**Ministerial Planning Referral: TPM-2016-3
24-46 A'Beckett Street, Melbourne**

19 April 2016

Application number:	TPM-2016-3
DTPLI Application number:	PA1500059
Applicant / Owner / Architect:	SJB Planning Pty Ltd, RMIT University, Denton Corker Marshall
Address:	24-46 A'Beckett Street, MELBOURNE VIC 3000
Proposal:	Construction of a multi-storey mixed use building
Cost of works:	\$137.4 million
Date received by City of Melbourne:	29 December 2015
Responsible officer:	Billy Rebakis
Report Date:	06 April 2016

Figure Six: Plan showing proposed setbacks and existing/approved built form on adjoining sites.

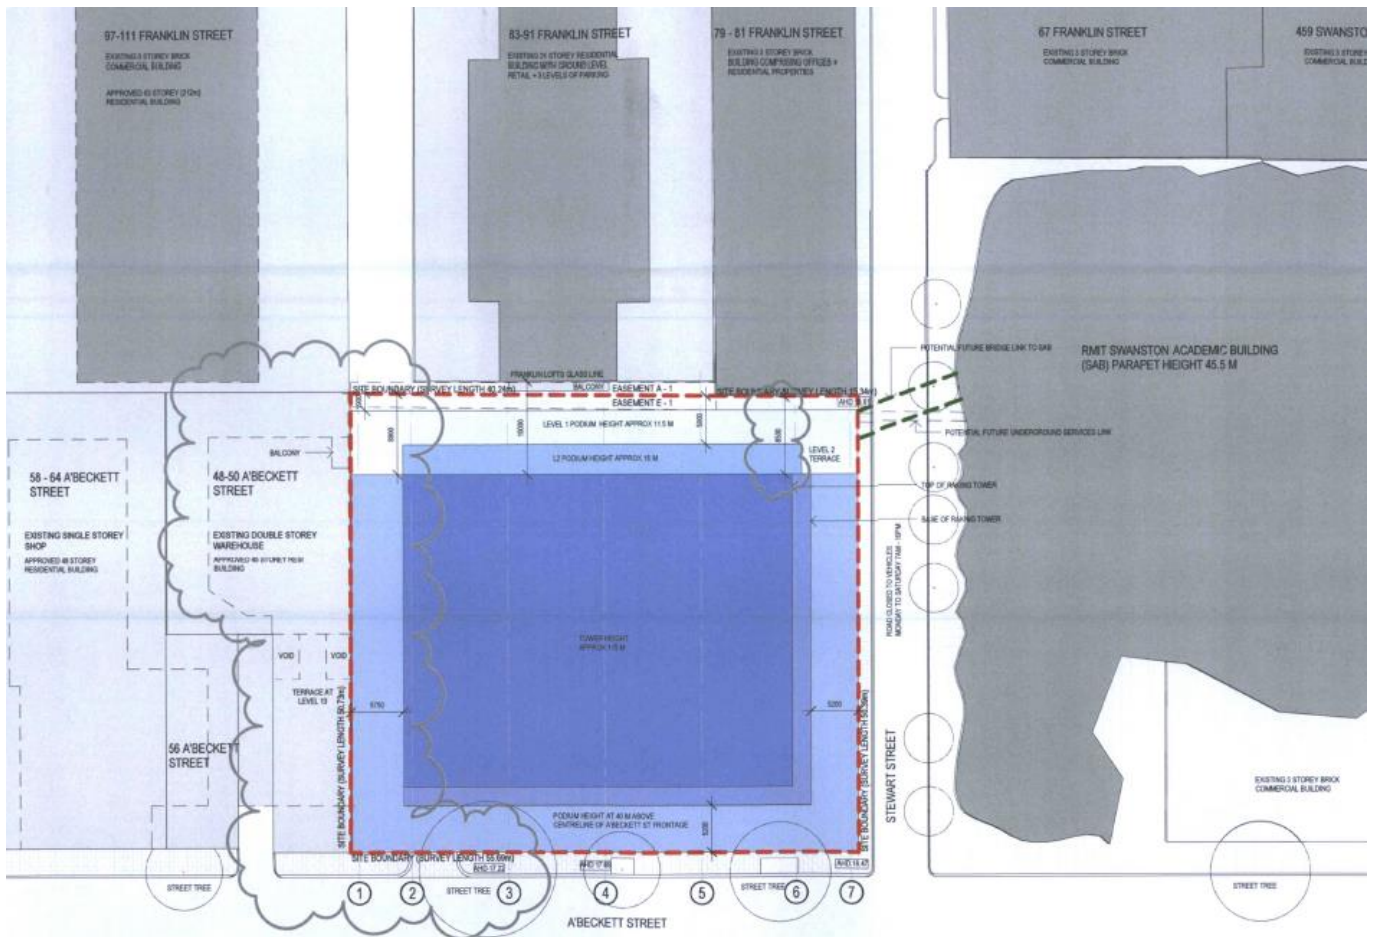
The proposal is setback 6.8m from the Franklin Loft (83-91 Franklin Street) building glass line at level 2 and 10m above level 10. This site has south facing balconies on the boundary which will benefit from 10m tower separation to the subject site.

The building fronts A'Beckett Street to the south. The podium is built to the boundary up to 40m while the tower is setback 5.2m off the podium. This complies with the requirements of DDO10 and respects the existing built form in the immediate area.

The podium is built to the eastern side boundary which creates an effective building separation of 13.2m (10m for Stewart Street and 3.2m minimum building setback) for the 40m podium height. The RMIT Building 80 is 45.5m high thus is only 5.5m higher than the subject sites' podium. Above podium level, the proposal is setback an additional 5.2m off Stewart Street. This is considered appropriate as there will be a noticeable appreciation of the tower form from the east as the majority of the tower will be seen due to the low maximum building height of the RMIT Building.

The building at 48-50 A'Beckett Street has an existing approval where there is a boundary wall extending the majority of the height of the building. The wall is solid to level 2 and between levels 2 and 12 there is a light court of 2.65m depth x 5m width. From levels 12 to 42, there is no light court but the boundary wall is limited to the tower element of the site, which is to the northern side.

Figure Seven: Summary of ground level wind condions as described by the Mel Consultants report.

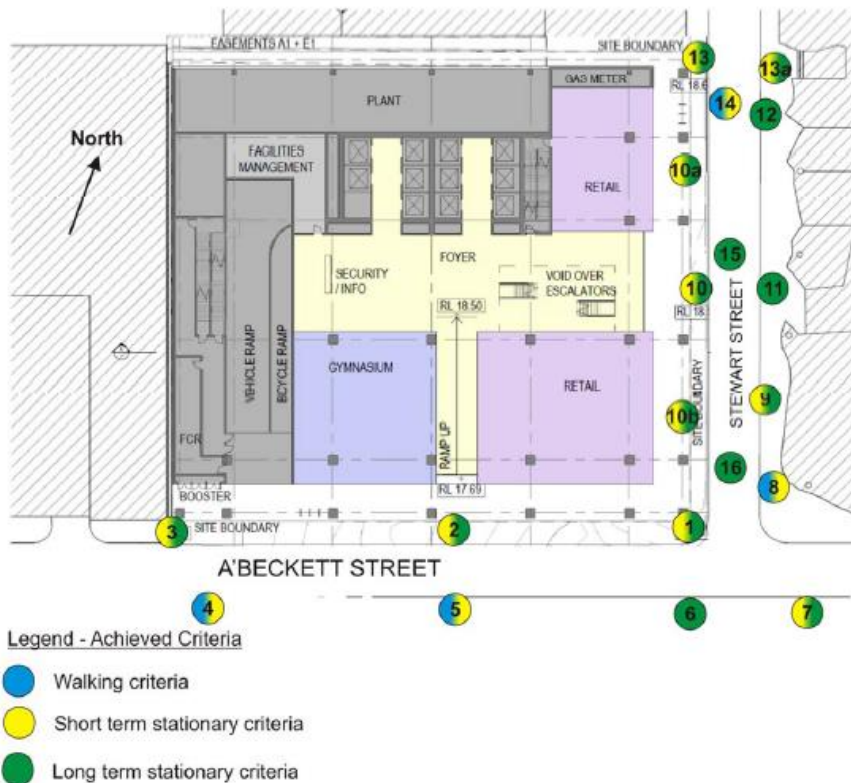
An environmental wind assessment has been undertaken by MEL Consultants dated December 2015 which found that the proposed development achieves:

- The criterion for walking comfort for all wind directions along A’Beckett Street. It achieves the short term stationary activities criteria with many directions achieving the long term stationary criteria.
- The criterion for walking comfort for all wind directions along Stewart Street, with the majority wind directions achieving the short term stationary criterion. The short term stationary criterion for all wind directions at both the A’Beckett Street and Stewart Street entrances of the proposed development.

Clause 37.04-7.0, states that “All other areas (outside DDO1) should be designed to be generally acceptable for short term wind exposure”. The results of the wind test, as shown in figure seven below, comply with this provision as the majority of wind directions achieve short term stationary criterion (yellow colour) while many achieve long term stationary criteria (green colour).
